**METROPOLITAN GOVERNMENT OF NASHVILLE AND DAVIDSON COUNTY**

**STAFF RECOMMENDATION**  
**919 McFerrin Avenue**  
**February 19, 2014**

**Application:** New construction—infill  
**District:** Greenwood Neighborhood Conservation Zoning Overlay  
**Council District:** 06  
**Map and Parcel Number:** 08204037800  
**Applicant:** William Gant, owner  
**Project Lead:** Melissa Baldock, melissa.baldock@nashville.gov

<p><b>Description of Project:</b> Application is to construct infill on a vacant parcel.</p> <p><b>Recommendation Summary:</b> Staff recommends disapproval of the infill, finding that its tall porch wall height, lack of a defined foundation, flat roof form, stucco cladding, and proportion and rhythm of openings do not meet Section II.B.1. of the <i>Greenwood Neighborhood Conservation Zoning Overlay: Handbook and Design Guidelines</i>.</p> <p>Staff finds that the basic massing, scale and layout of the house is appropriate and a simple alteration of roof form, materials and windows are all that are needed to meet the design guidelines. Although these alterations are simple to accomplish, they do radically change the look of the building which is why Staff is not recommendi

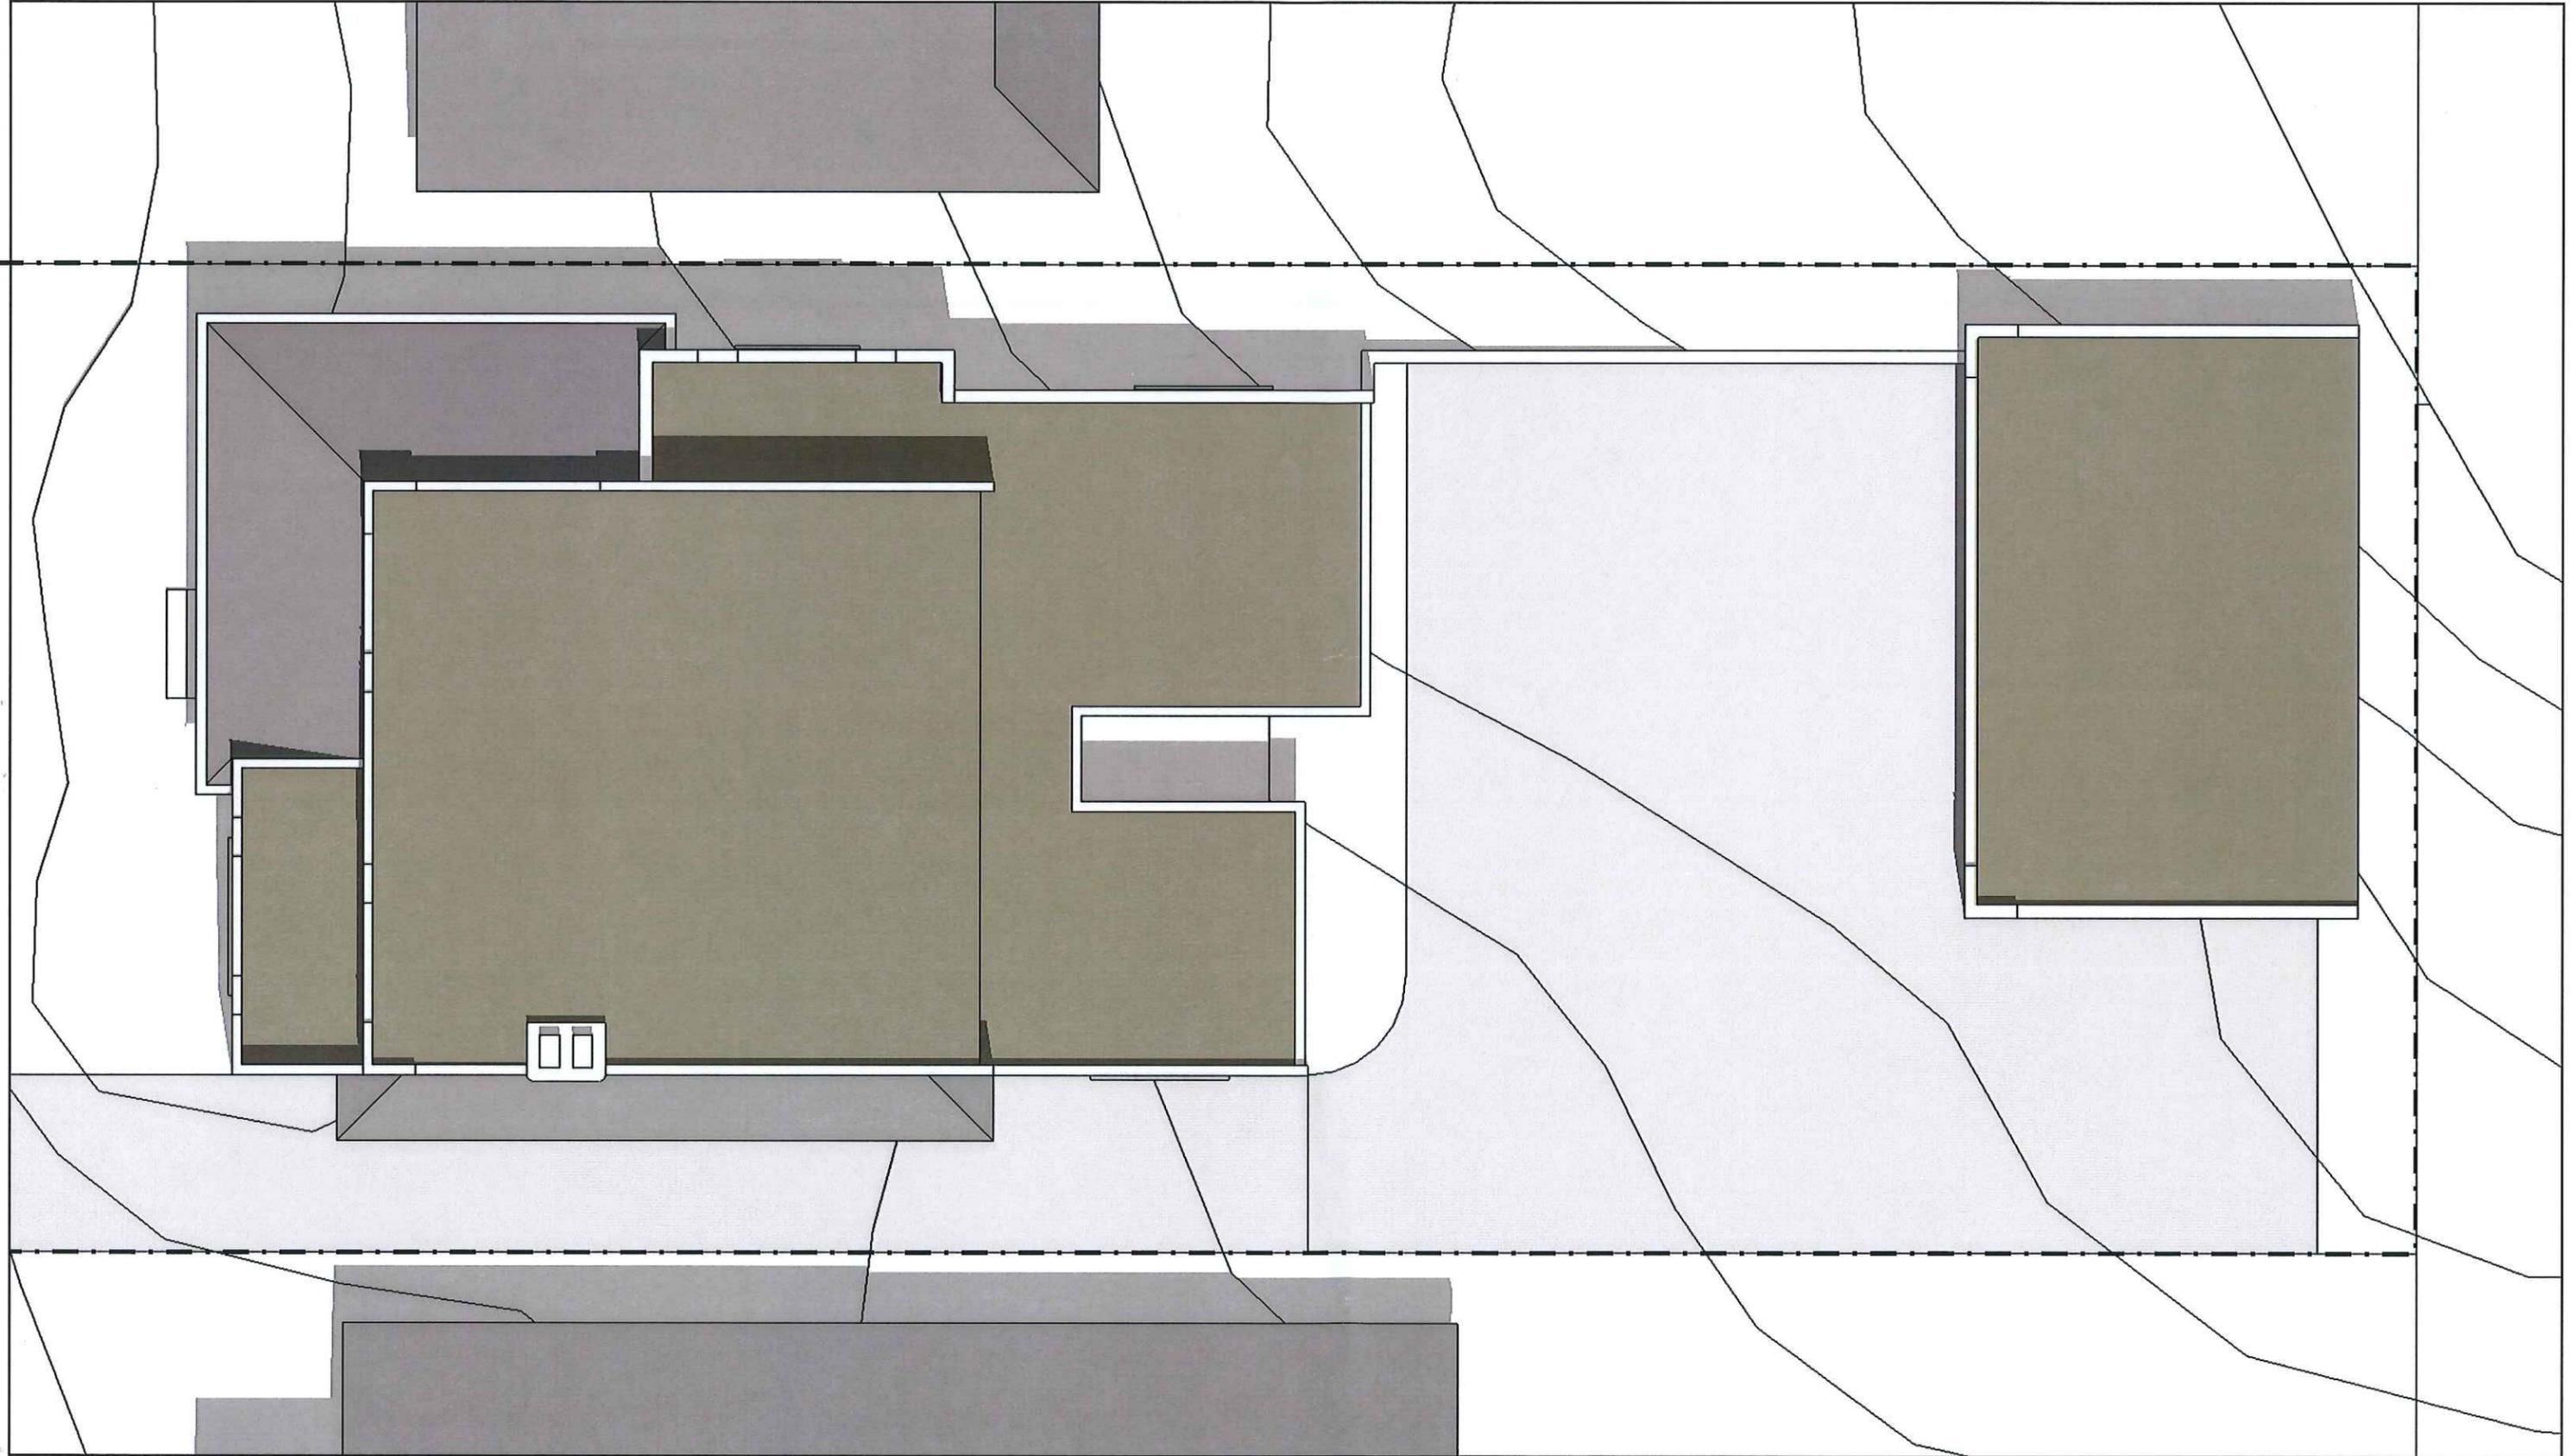
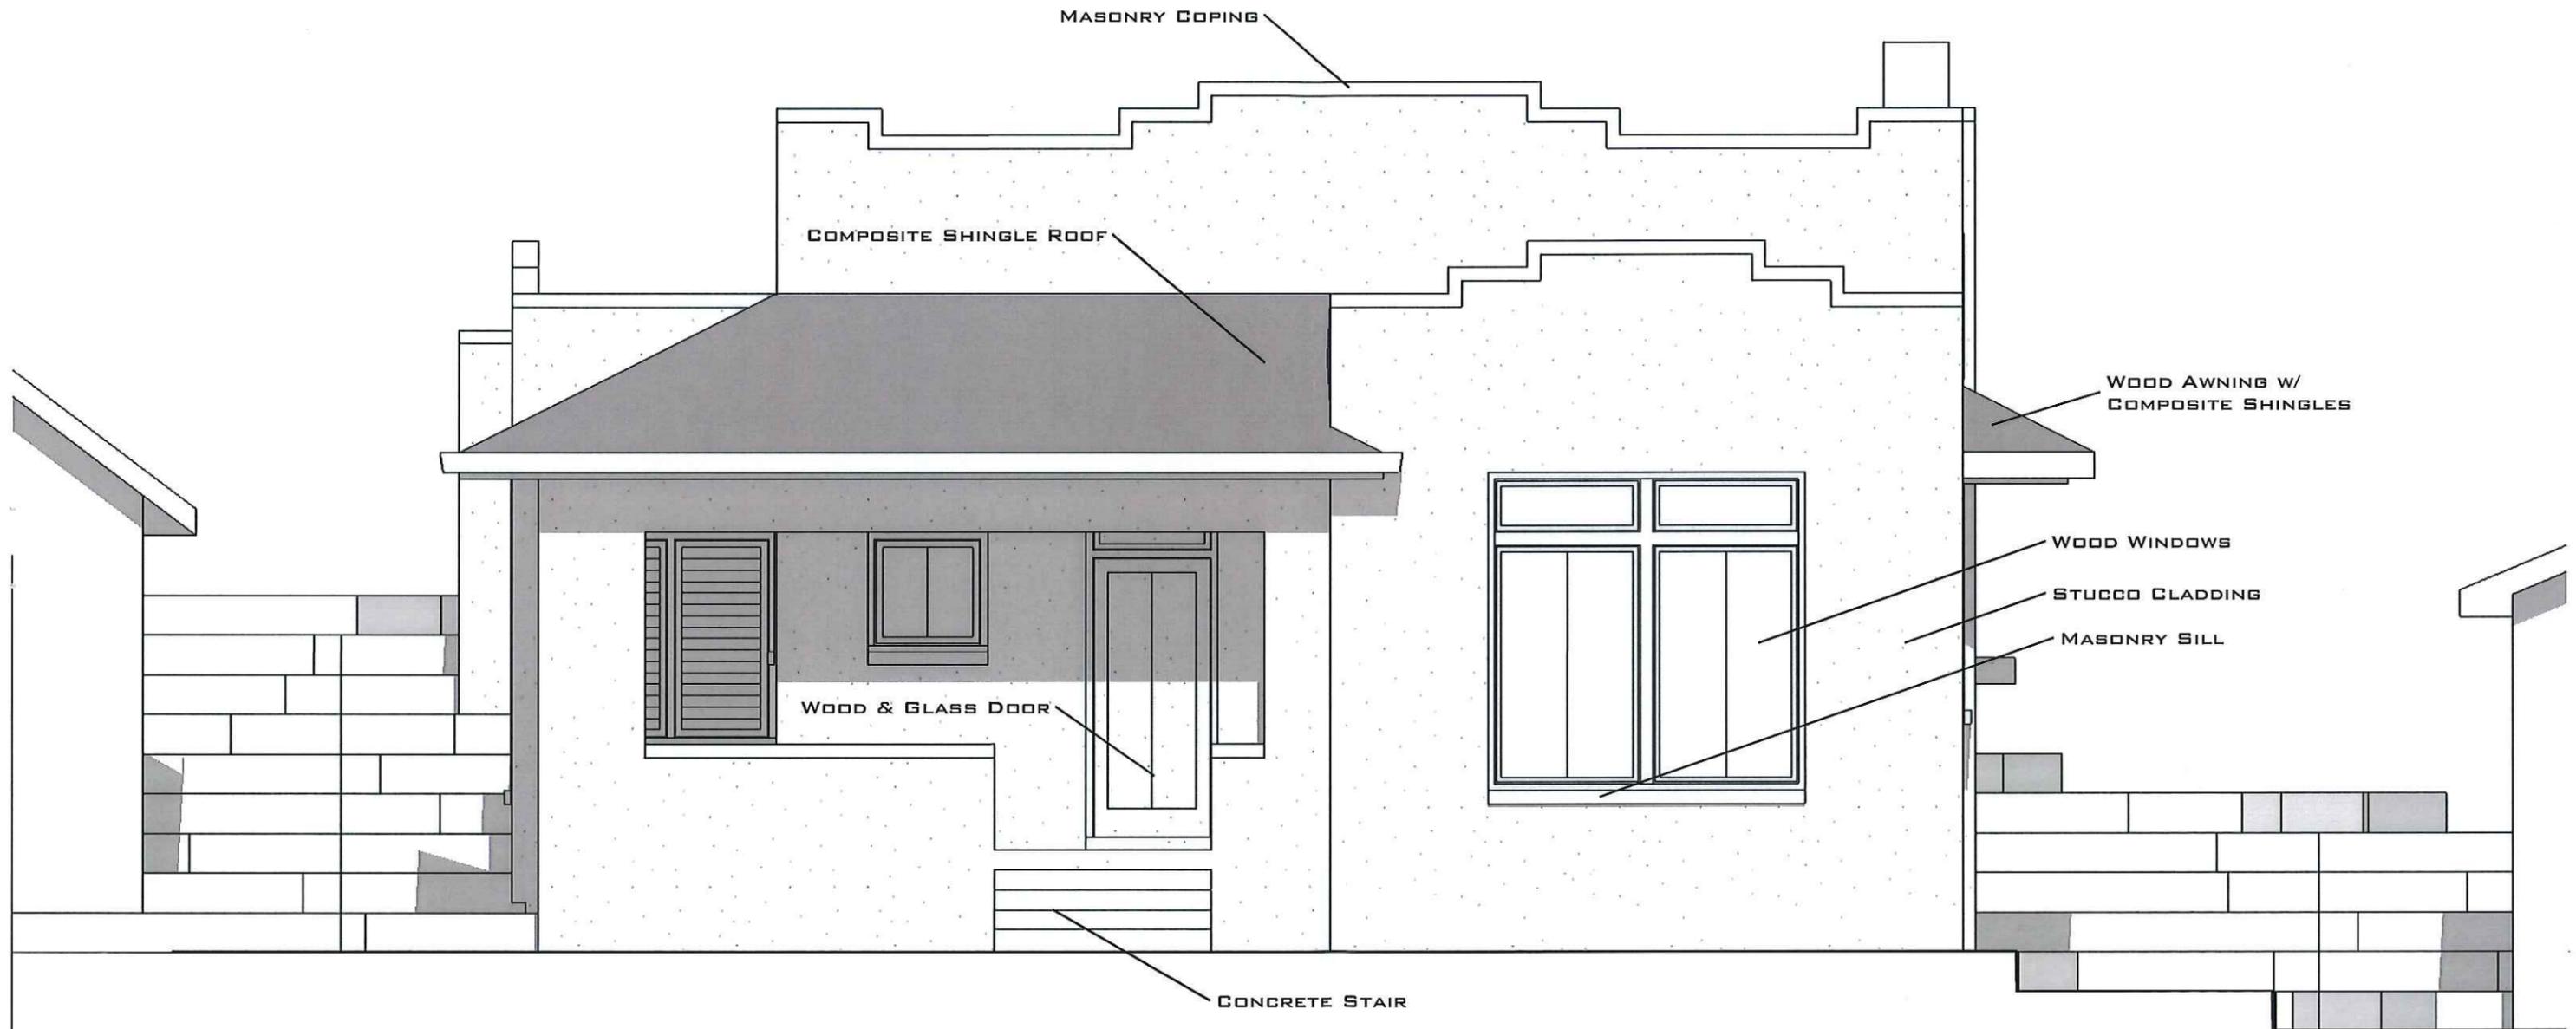
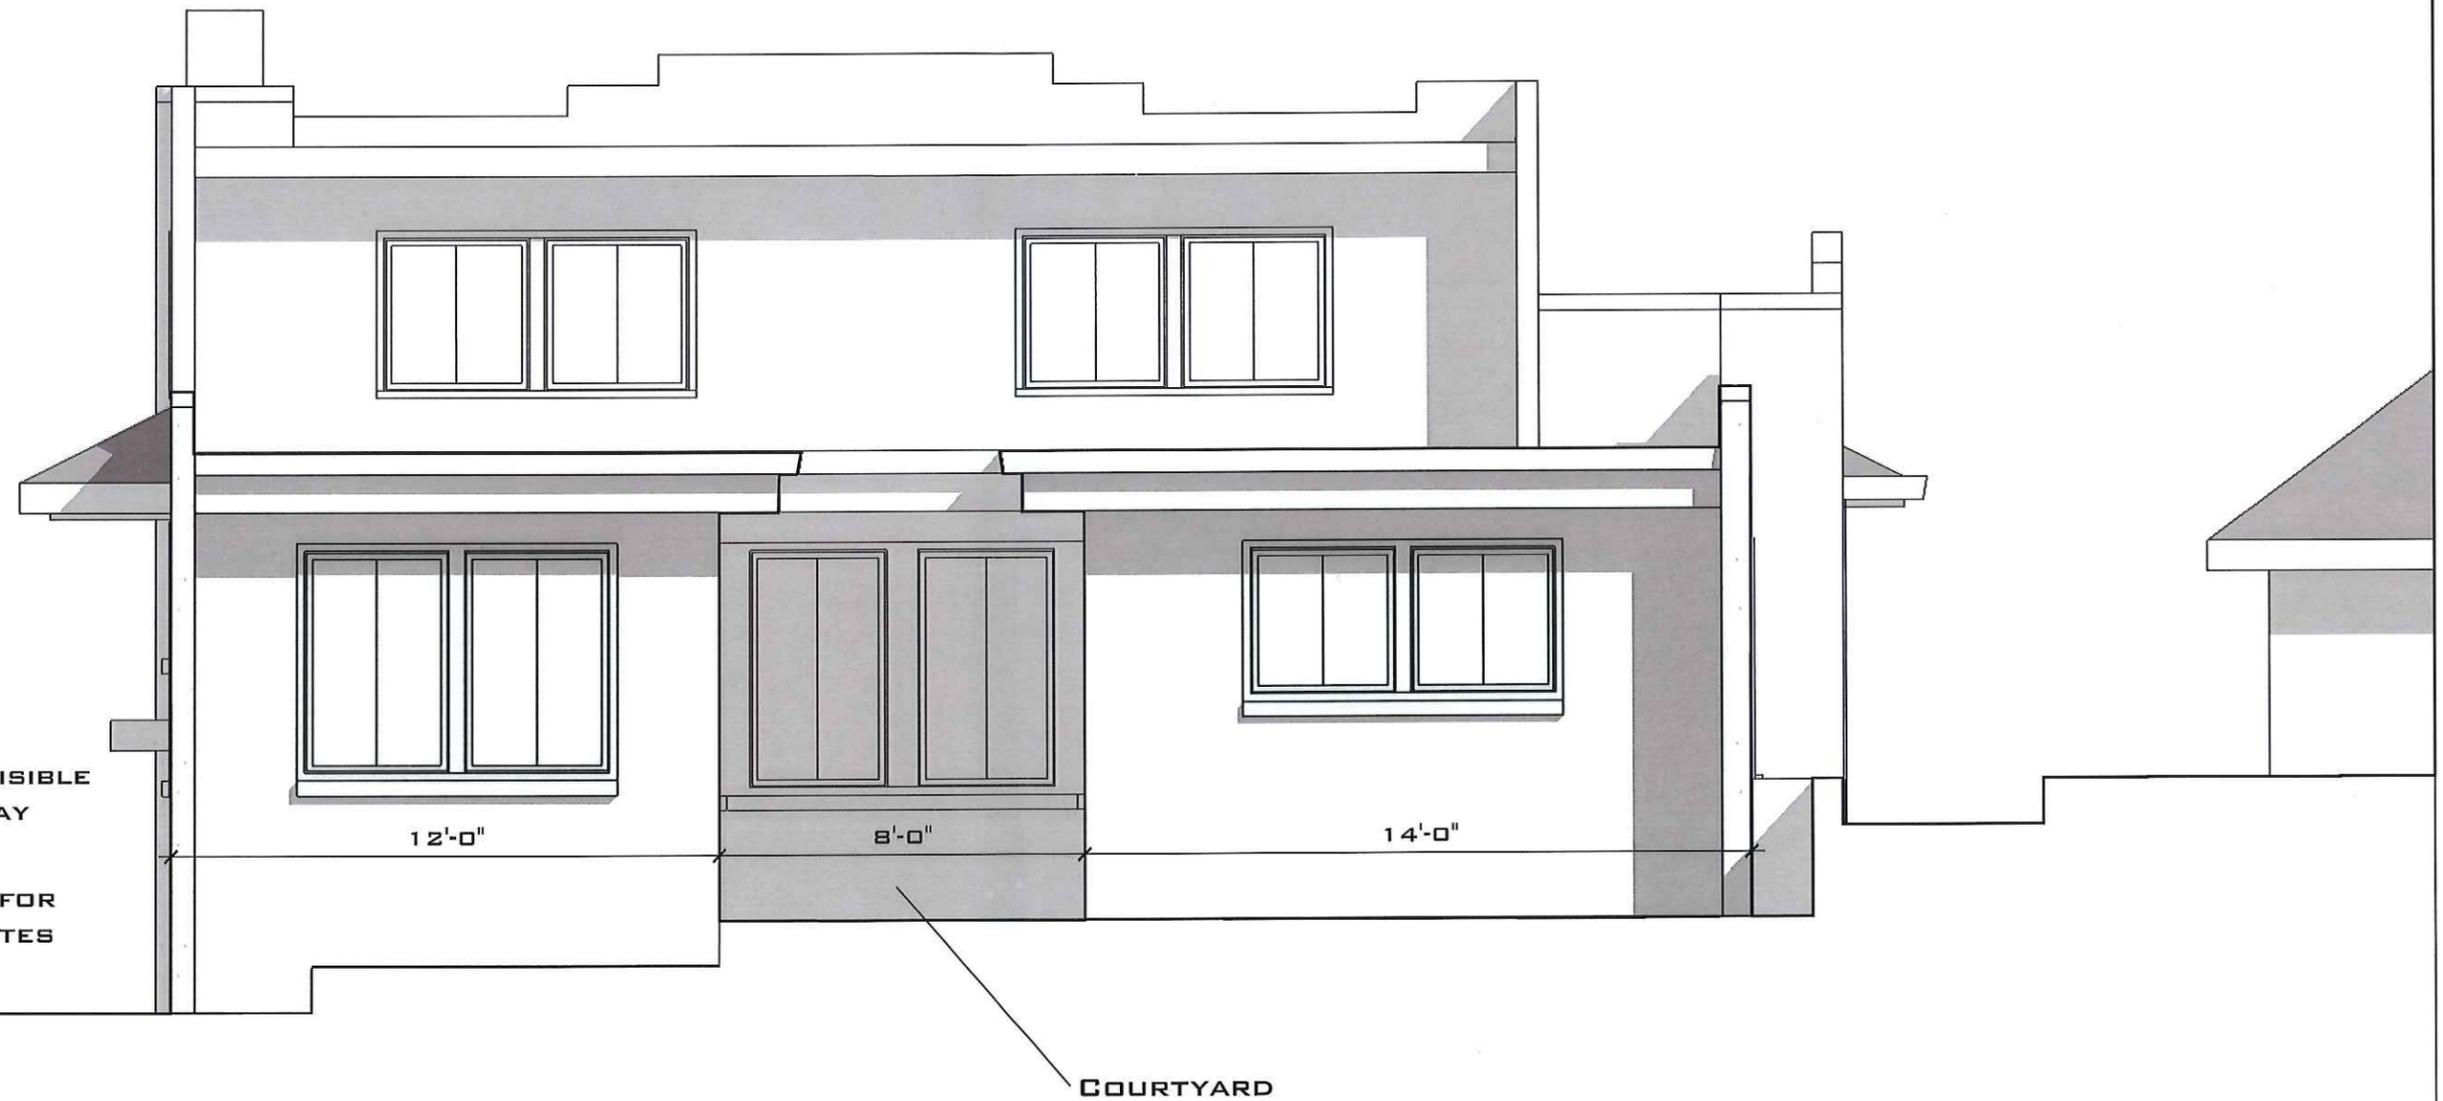
The house lacks a foundation line, so there is no foundation height to measure. This is not typical of historic houses in the Greenwood neighborhood, which have a change in material from the foundation to the cladding above. The five foot (5') tall porch wall is also atypical for the Greenwood area. This type of tall wall creates a somewhat "enclosed" porch design which is more typical of architectural styles that are not found in this neighborhood. More characteristic here are porches with open railings or no railings and narrower posts, creating a more open feel.

While the overall height and width of the proposed infill matches the historic context, the lack of a defined foundation line and the tall front porch wall do not match the historic context. Staff therefore finds that the infill does not meet sections II.B.1.a. and b. of the *Greenwood Neighborhood Conservation Zoning Overlay: Handbook and Design Guidelines*.

Materials: The primary material for the infill is stucco. Staff did not identify any historic structure in the Greenwood conservation overlay with stucco as its primary material. The vast majority of the historic structures in the neighborhood have brick or lap siding as their primary material. The porch roof and side awning will be composite shingle, which is appropriate. The parapet will have masonry coping. The windows and front door will be wood. Because the stucco facade is not appropriate for the Greenwood neighborhood, staff finds that the project's materials do not meet Section II.B.1.d. of the *Greenwood Neighborhood Conservation Zoning Overlay: Handbook and Design Guidelines*.

Roof form: The applicant is proposing a flat roof form for the majority of the house, with a hipped porch roof and a hipped awning on the right/south façade. Staff did not identify any flat roof residential structures in the Greenwood conservation zoning overlay. Therefore staff finds that the roof form is incompatible with the surrounding historic roof forms which are generally gabled or hipped. Staff finds that the infill's flat roof does not meet Section II.B.1.e. of the *Greenwood Neighborhood Conservation Zoning Overlay: Handbook and Design Guidelines*.

Proportion and Rhythm of Openings: The primary windows are generally twice as tall as they are wide, thereby meeting the historic proportion of window openings. One exception is a three foot by three foot (3' X 3') window opening on the front façade, to the left of the door. A window like this on the front façade should be at least twice as tall as it is wide. The front façade has a window opening that is filled with shutters and wraps around the corner to the north/left façade. It is not clear if the shutters are fixed or if they are operable. In either case, staff finds that the shutters do not meet the design guidelines. Staff requires more information on the shutters before determining whether or not they meet the design guidelines. Staff finds the project's proportion and rhythm of openings do not meet Section II.B.1.g. of the *Greenwood Neighborhood Conservation Zoning Overlay: Handbook and Design Guidelines*.

Staff recommends disapproval of the infill, finding that its tall porch wall height, lack of a defined foundation, flat roof form, stucco cladding, and proportion and rhythm of openings do not meet Section II.B.1. of the *Greenwood Neighborhood Conservation Zoning Overlay: Handbook and Design Guidelines*.

Staff finds that the basic massing, scale and layout of the house is appropriate and a simple alteration of roof form, materials and windows are all that are needed to meet the design guidelines. Although these alterations are simple to accomplish, they do radically change the look of the building which is why Staff is not recommending approval with conditions.
